SUBJECT: NuScale Power, LLC Supplemental Response to NRC Request for Additional Information No. 9466 (eRAI No. 9466) on the NuScale Topical Report, "Non-Loss of Coolant Accident Analysis Methodology," TR-0516-49416, Revision 1

NuScale Supplemental Response to NRC Request for Additional Information eRAI No. 9466

NRC Question No.: 15.00.02-7

Figure 7-1 [Example of decay heat comparisons](#)

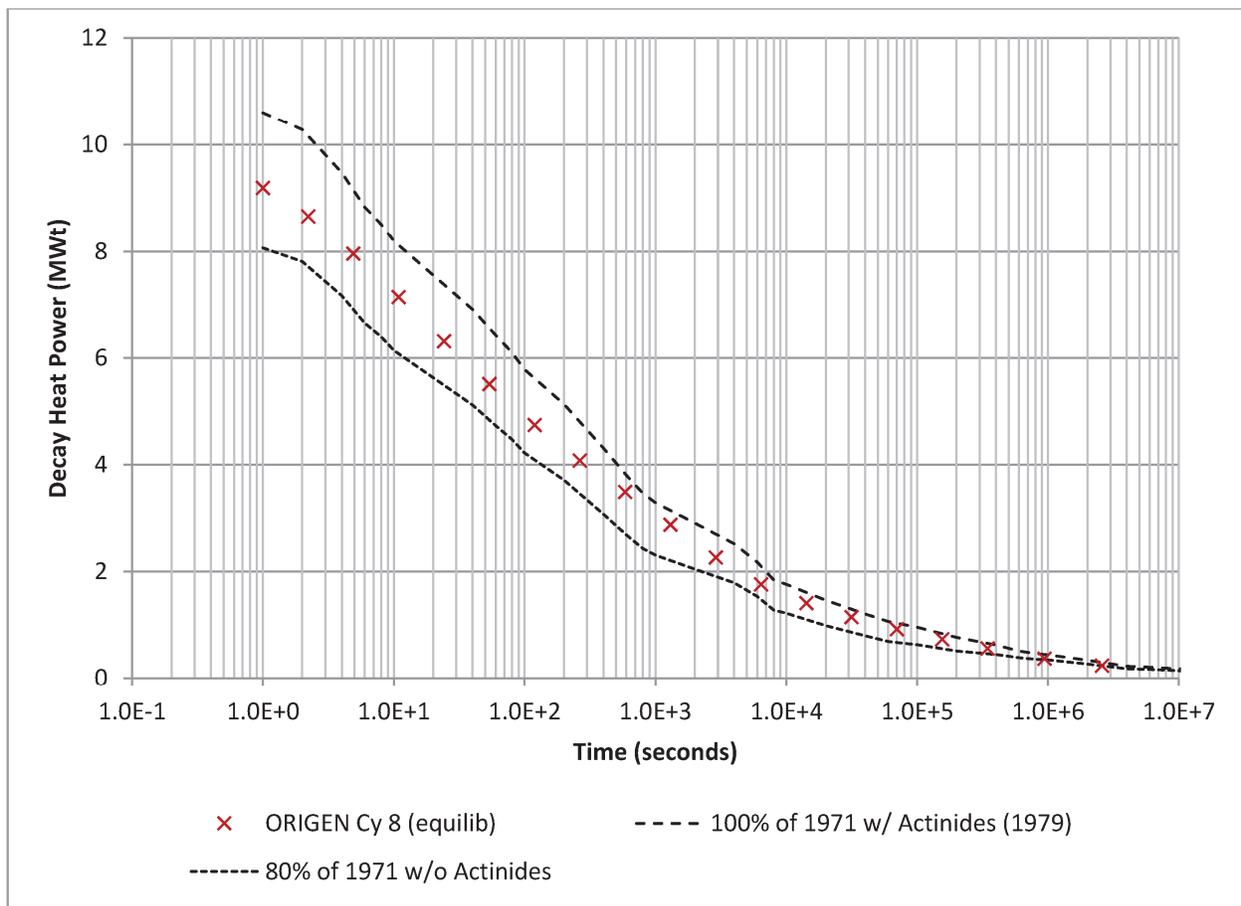
Provide the actual values of λ and η used and references for these parameters, and justify that the use of these values, the specified multipliers, and inclusion (or lack thereof) of actinides in combination with the 1973 decay heat model leads to a conservative result for decay heat contribution for all event types. Update TR-0516-49416-P and any other affected documentation as appropriate.

A best estimate decay heat curve was generated using the ORIGEN code for a generic equilibrium cycle. A sample figure which includes the minimum and maximum decay heat curves bounding the best estimate curve was added to the topical report Non-Loss of Coolant Accident Analysis Methodology, TR-0516-49416, as shown at the end of this response. The

The following decay heat contribution values are examples for the NPM. [Figure 7-1 provides an example of the decay heat as a function of time for an equilibrium cycle.](#) A review of the applicable core physics parameters is performed each cycle to confirm the bounding nature of the values utilized for the non-LOCA transient analyses.

- Low = use multiplier of 0.8 while excluding the actinide contribution
- High = use multiplier of 1.0 while including the actinide contribution
